20006
Blackglen Road, Lamb's Cross
Sandyford, Dublin 18
August 22nd 2022

E: Response to ABP + DLRCC Opinion

Proposed Residential Development at Blackglen Road

Strategic Housing Development

Main: Roof Plan with Storey Heights

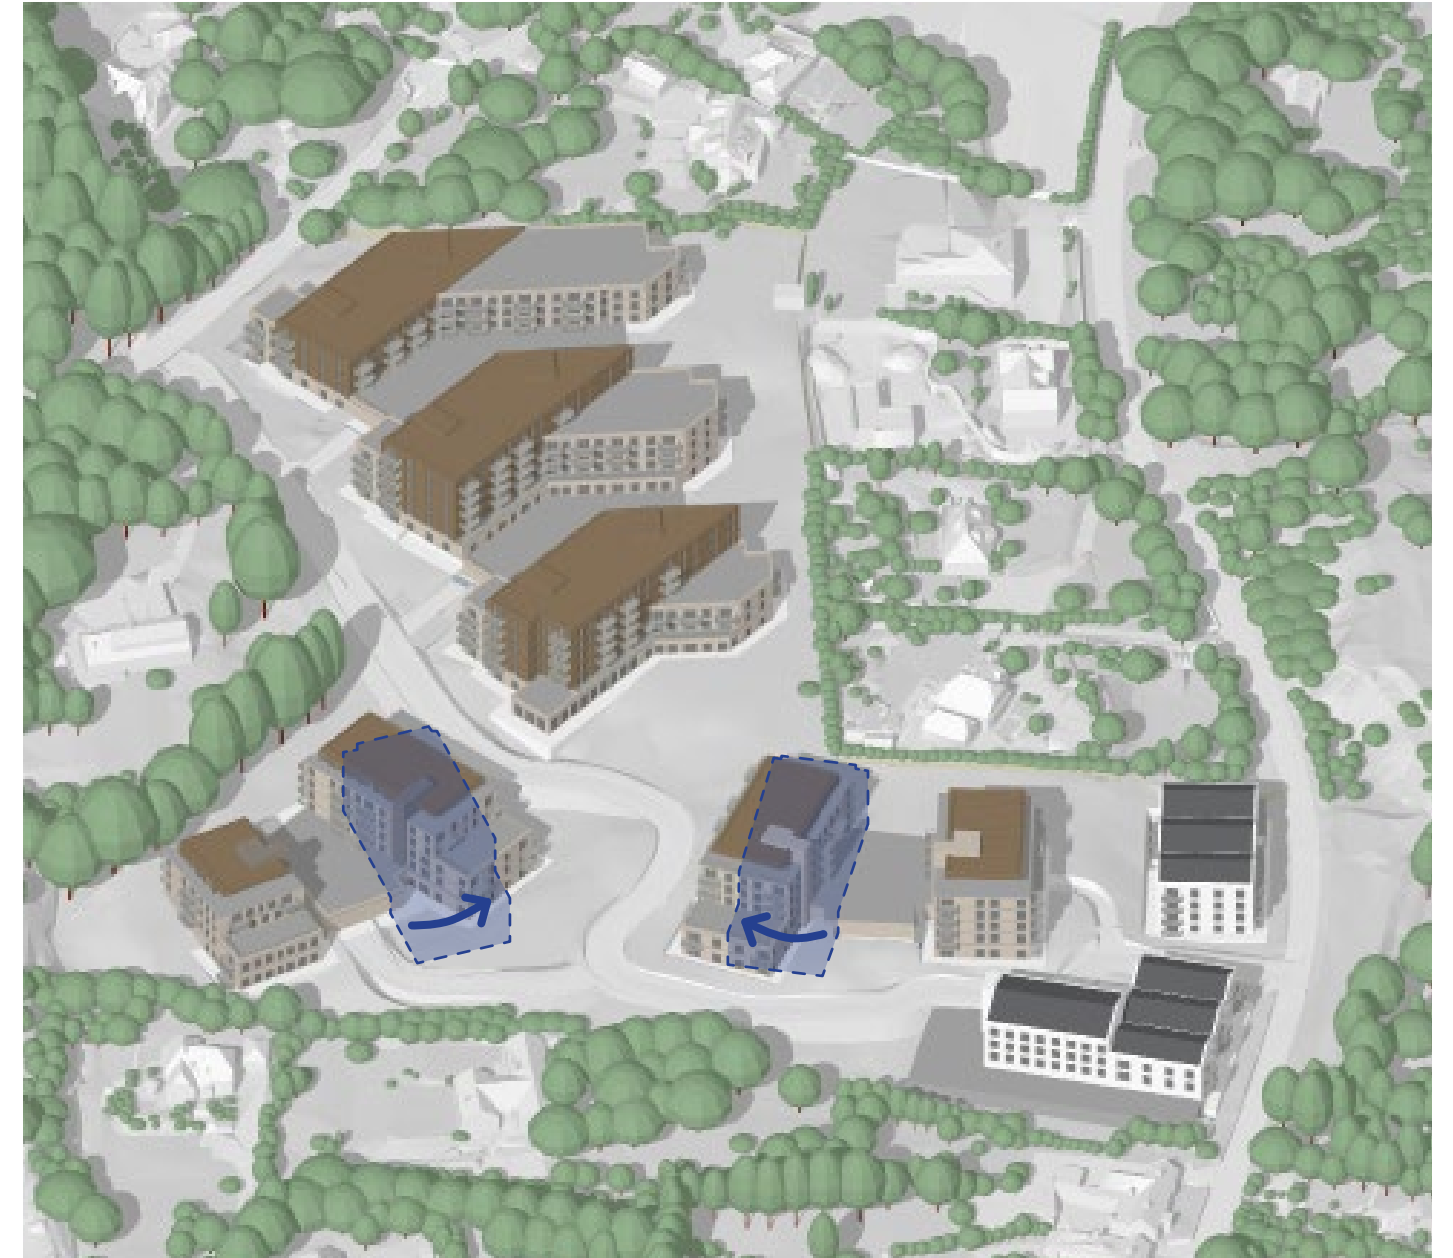
Responses to tripartite meeting: Scale and Massing

1. Reduced overall density and massing from tripartite presentation with the removal of block D
2. Reduced the height of block B3 by 1 storey
3. Reduced the height of block B4 by 2 storeys
4. Reduced the height of block C3 by 2 storeys

In addition to reducing the overall height and density, the current proposal has rotated and moved block B2 + B3 to increase the internal separation distances between these blocks.

● Verified View 09 - Tripartite Proposal

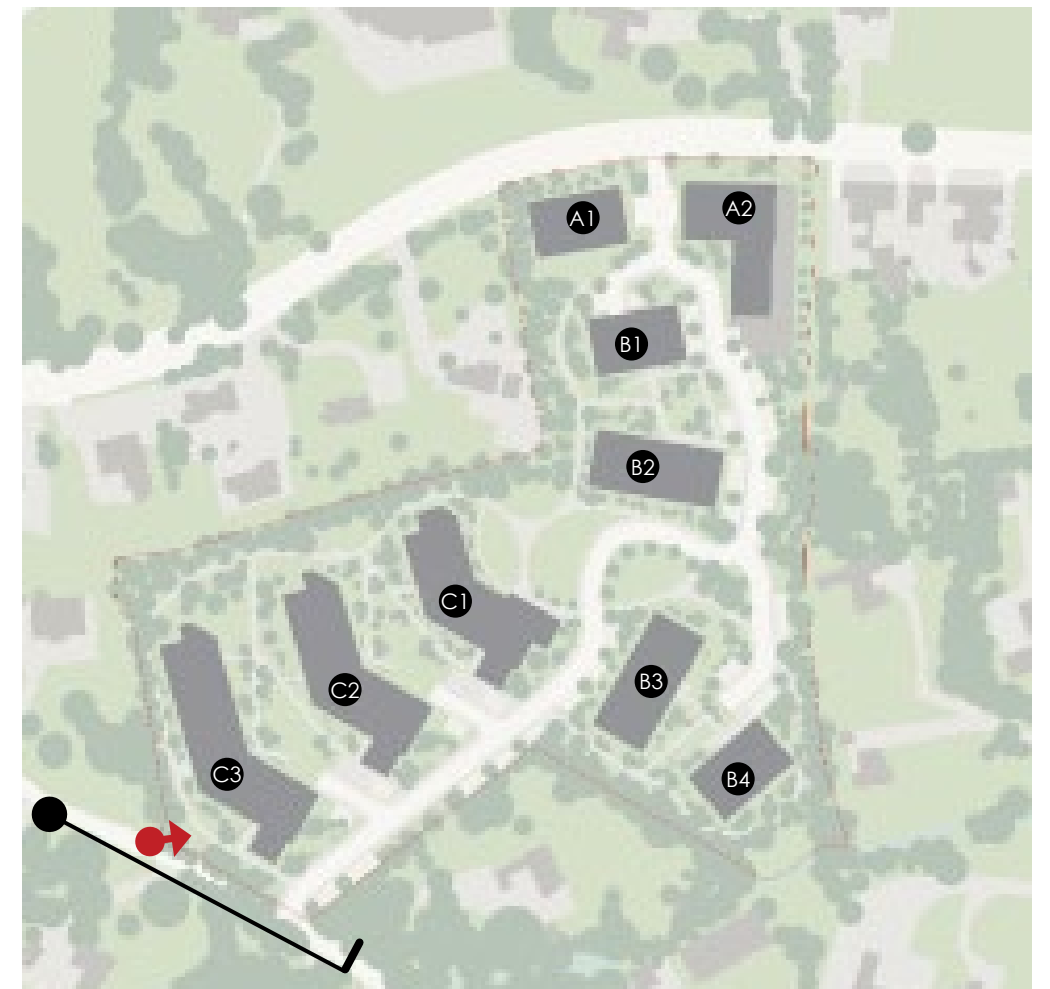
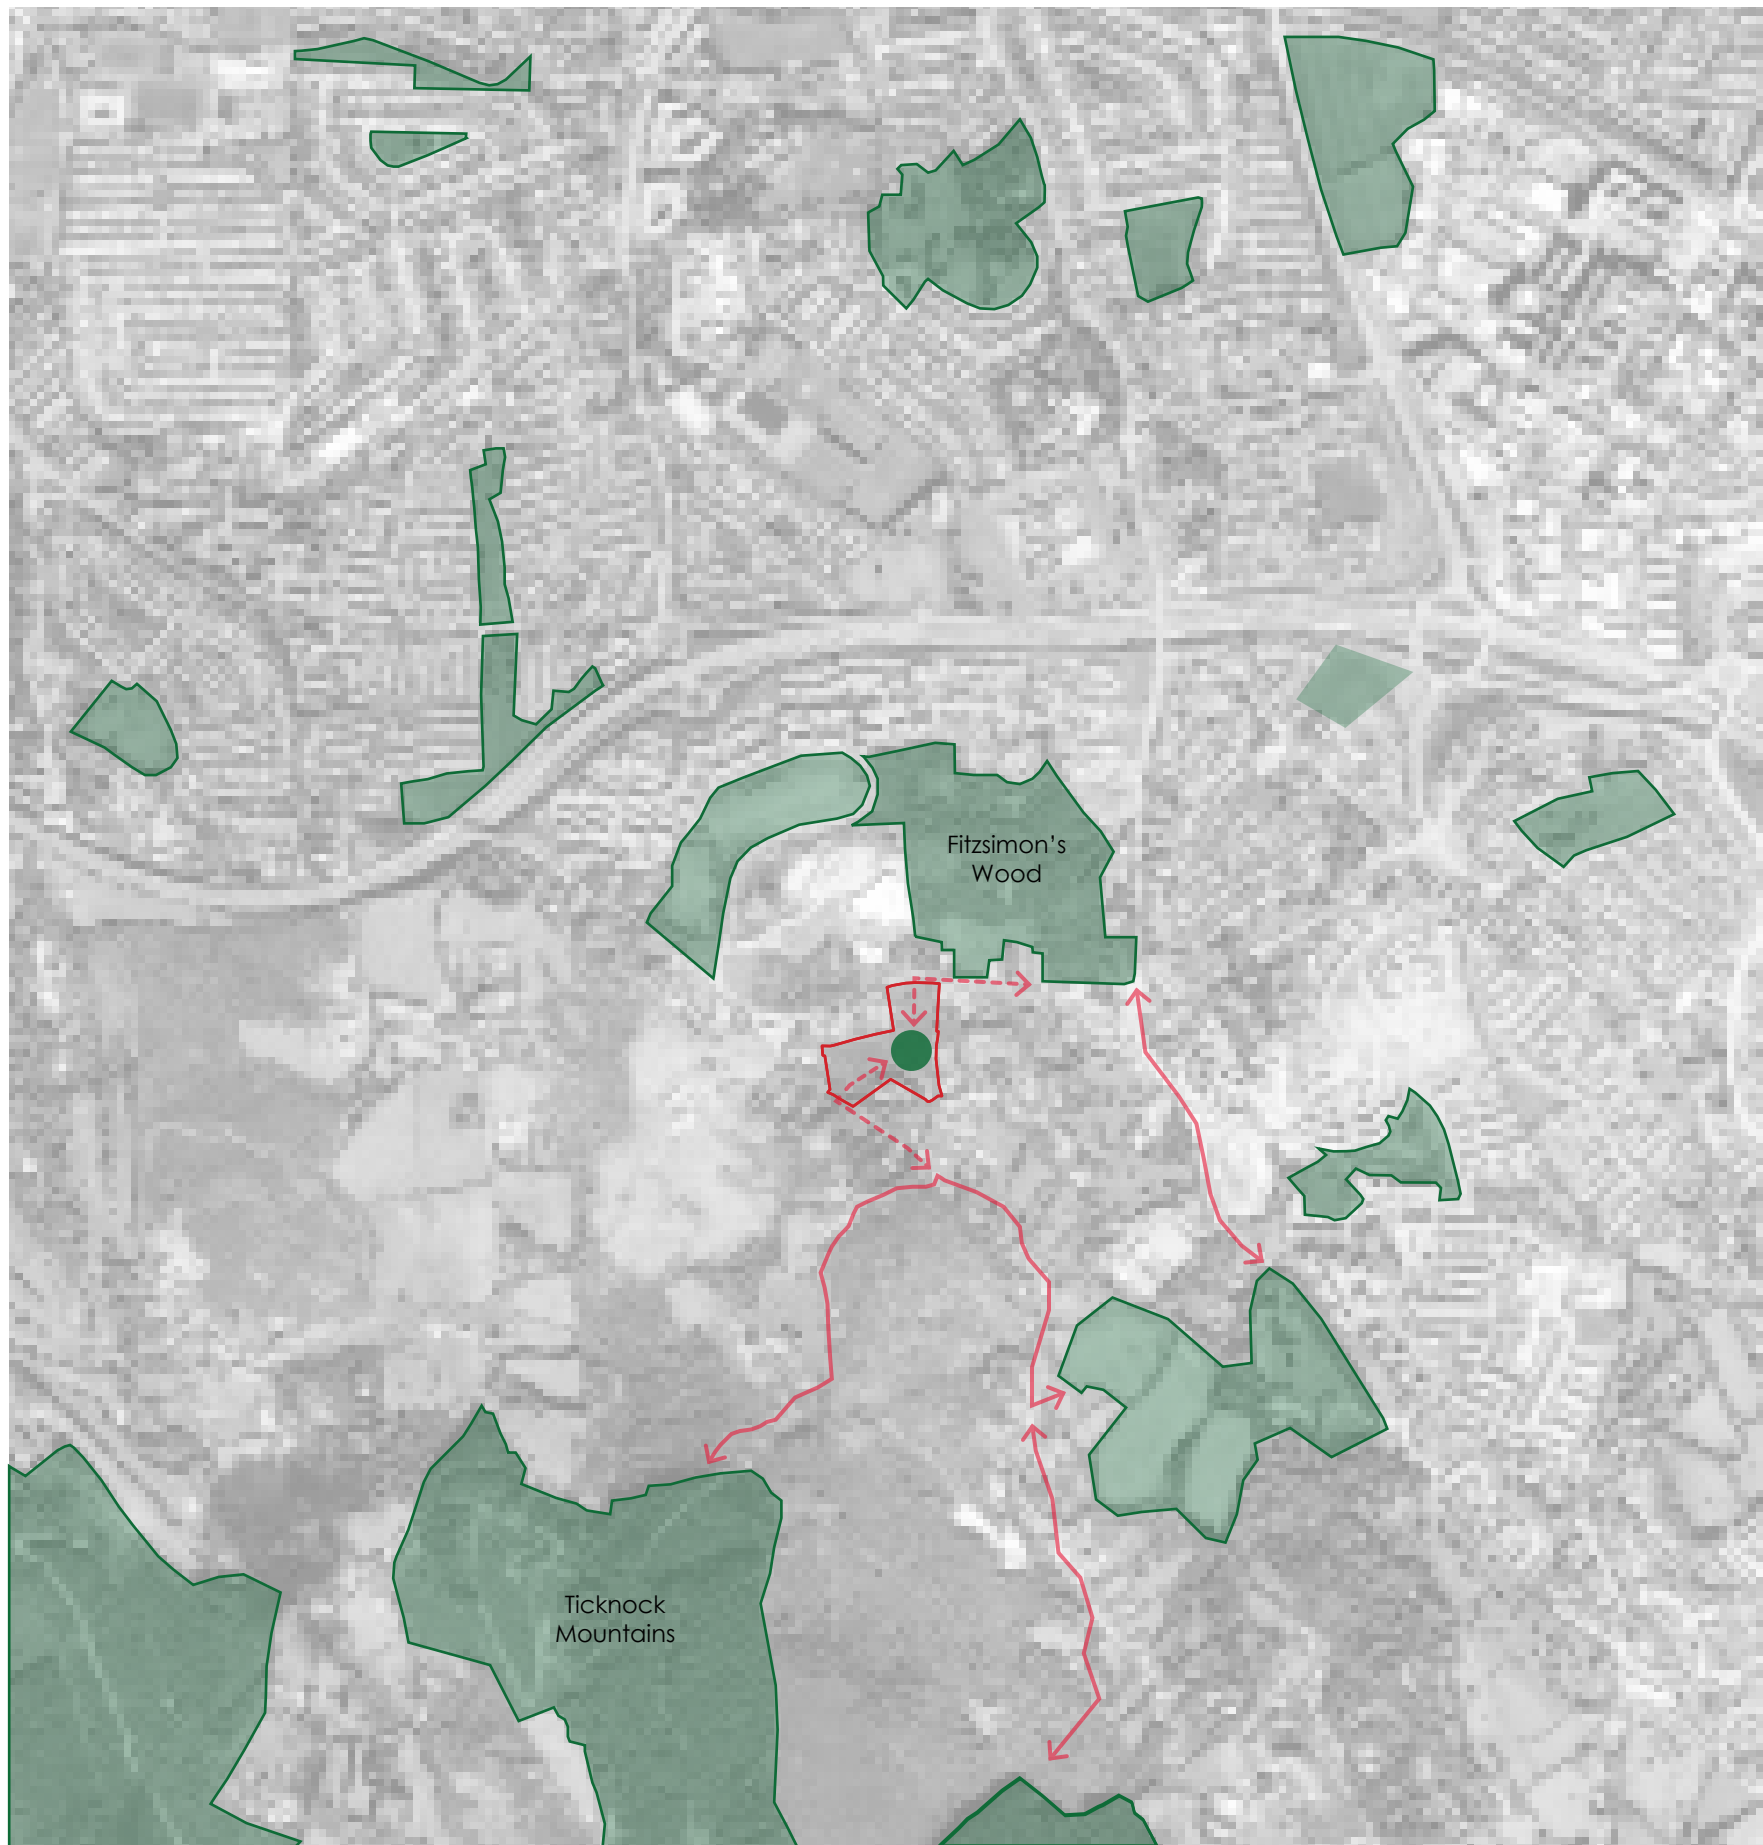
The adjacent cross section along woodside road, accompanied by the verified view 09, illustrates the reduction in building height in response to DLRCC comments and successful reduced visual impact with the development setback distances and landscape visual screening to this edge. This design response is considered an appropriate reduction in scale adjoining the transitional area along Woodside road having regard to the zoning objective 'G' and 'B'.

Responses to tripartite meeting: Scale and Massing

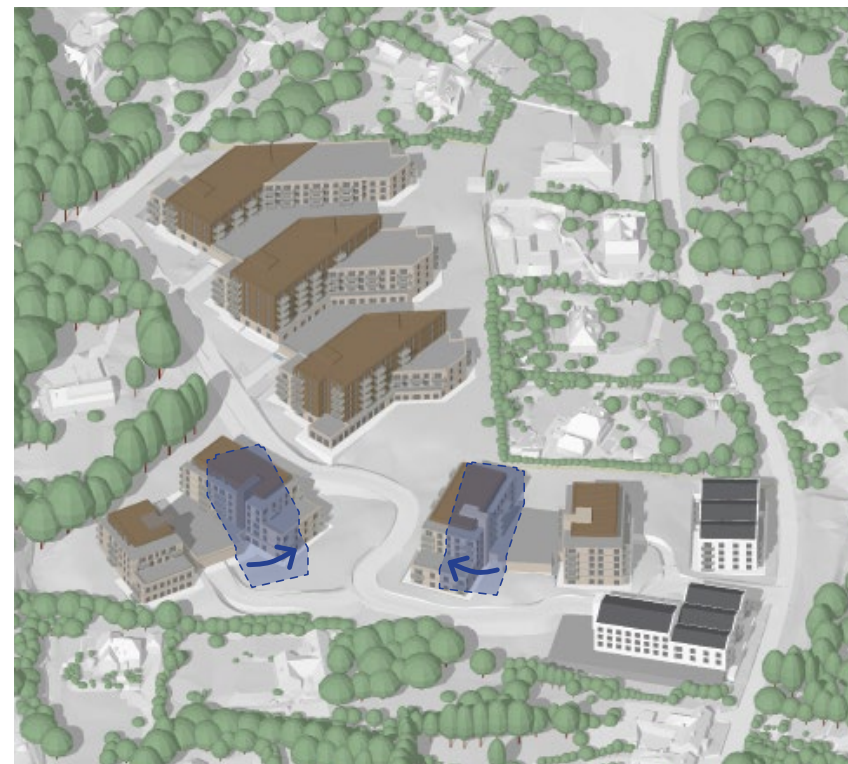
Following comments received at the Tripartite stage meeting, the building heights have been reduced by 2 storeys in certain locations, namely block C3 and blocks B3+B4 in response to the comments received. In addition, the entirety of Block D is removed from the development. This was originally proposed as an 8 storey 'tower house' typology element intended as a visual marker in the landscape and located at the centre of the site between the upper and lower hillside character areas to anchor and signify the main, central green open space. The design team have agreed to remove this element given the feedback in respect of the perceived impact in relation to height and visual prominence.

1. Reduced overall density and massing from tripartite presentation with the removal of block D
2. Reduced the height of block B3 by 1 storey
3. Reduced the height of block B4 by 2 storeys
4. Reduced the height of block C3 by 2 storeys

In addition to reducing the overall height and density, the current proposal has rotated and moved block B2 + B3 to increase the internal separation distances between these blocks.

1 Proposed Site Section

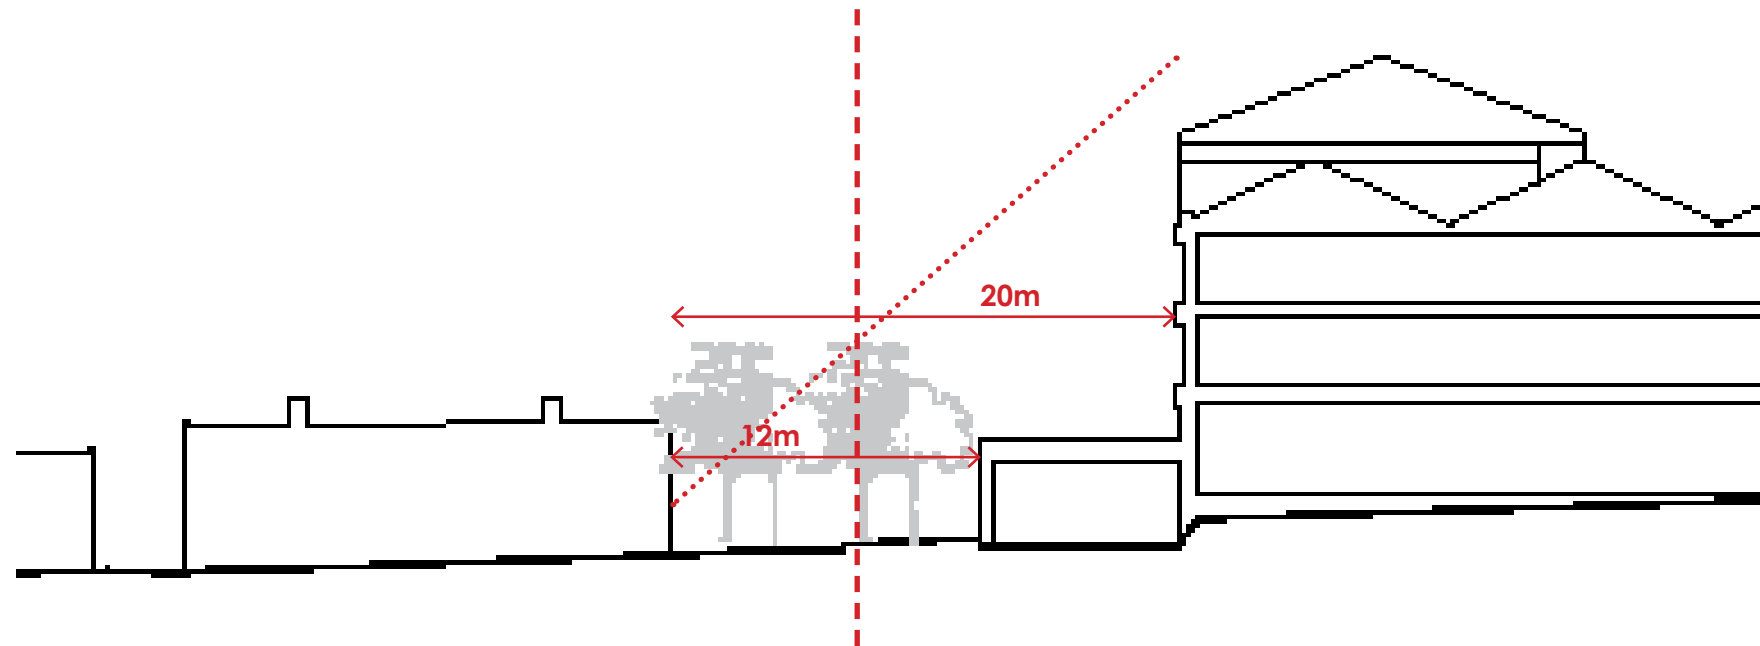
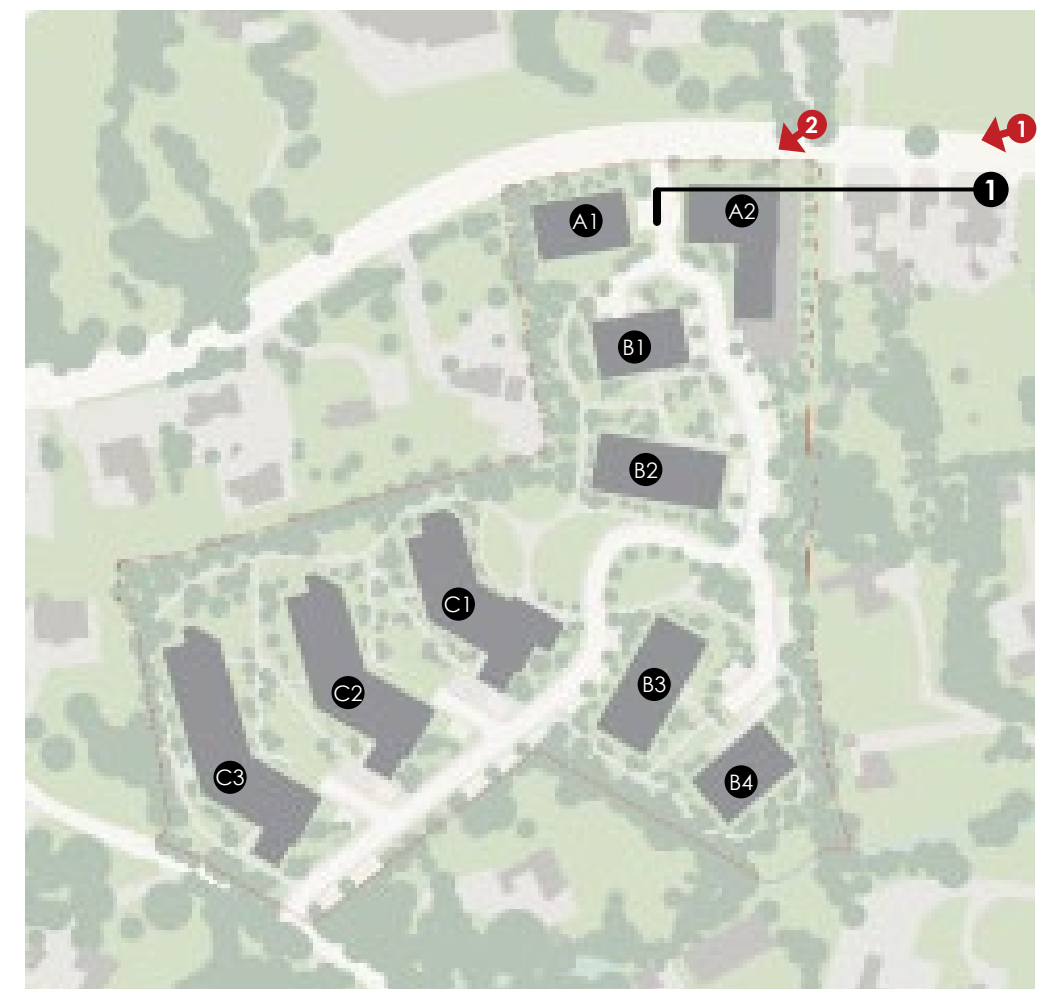
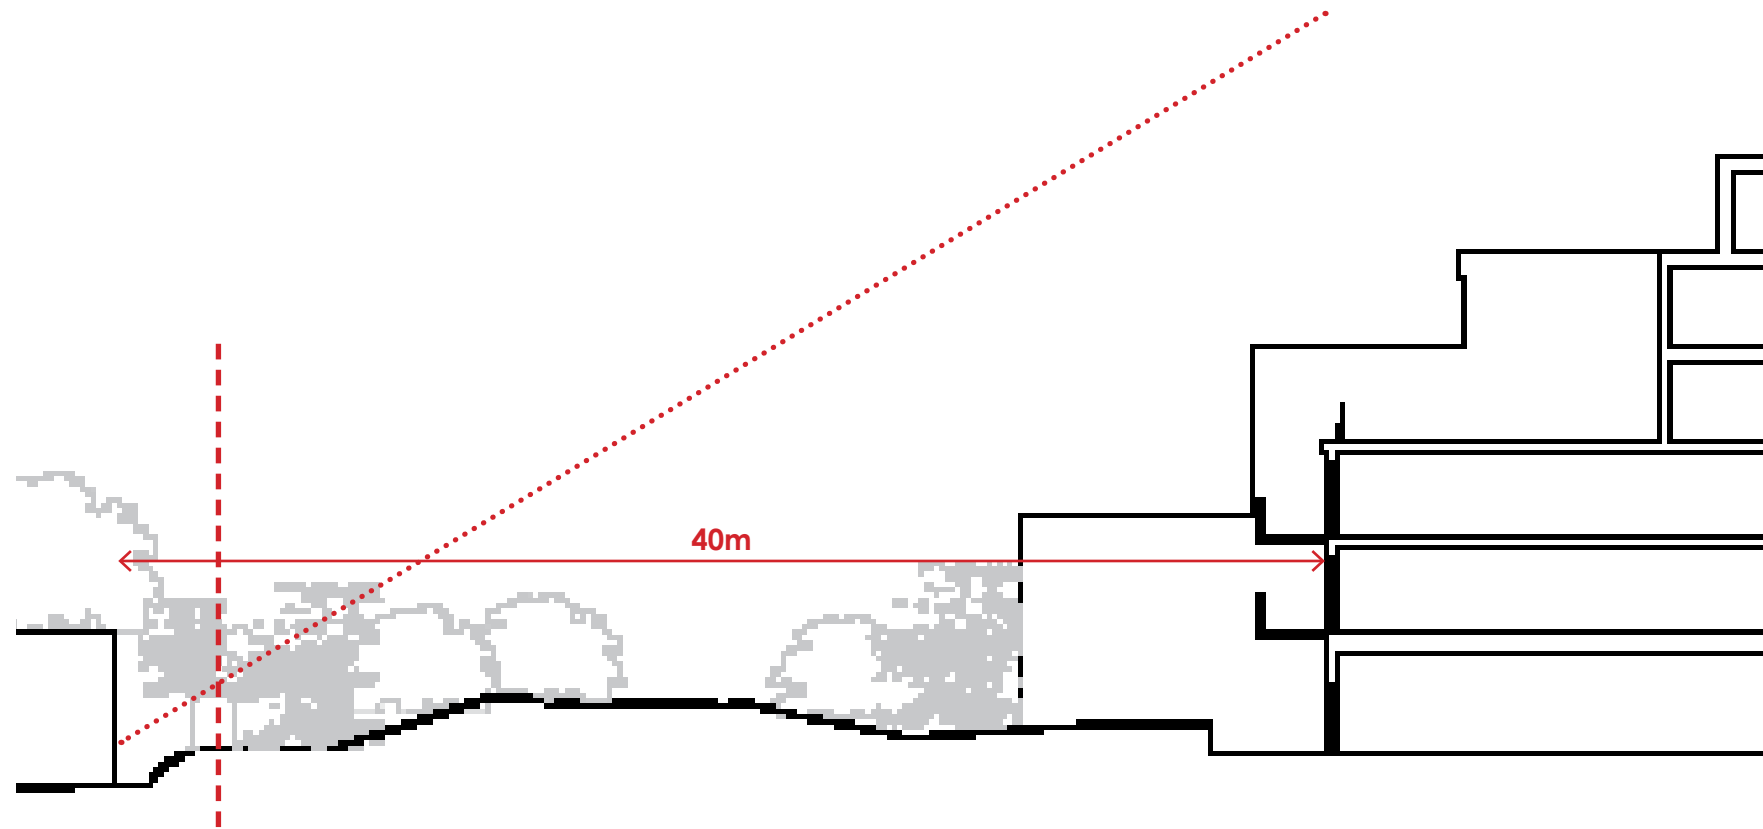
8. A report that addresses issues of residential amenity (both existing residents of adjoining development and future occupants), specifically with regards to potential overlooking, overshadowing and and overbearing. The report shall include full and complete drawings including levels and cross-sections showing the relationship between the proposed development and adjacent residential development, and comprehensive Daylight and Shadow Impact Assessment.

The separation distances between the proposed development and the surrounding Blackglen Road properties to the North are 12m at a podium level and 20m between adjacent residential windows.

In addition to the considerable setback distance provided along the North Eastern boundary, the visual impact from Blackglen Road is diminished further by the presence of the existing tree belt which provides a continuous 'green veil' along the East, South and Western boundaries to the site.
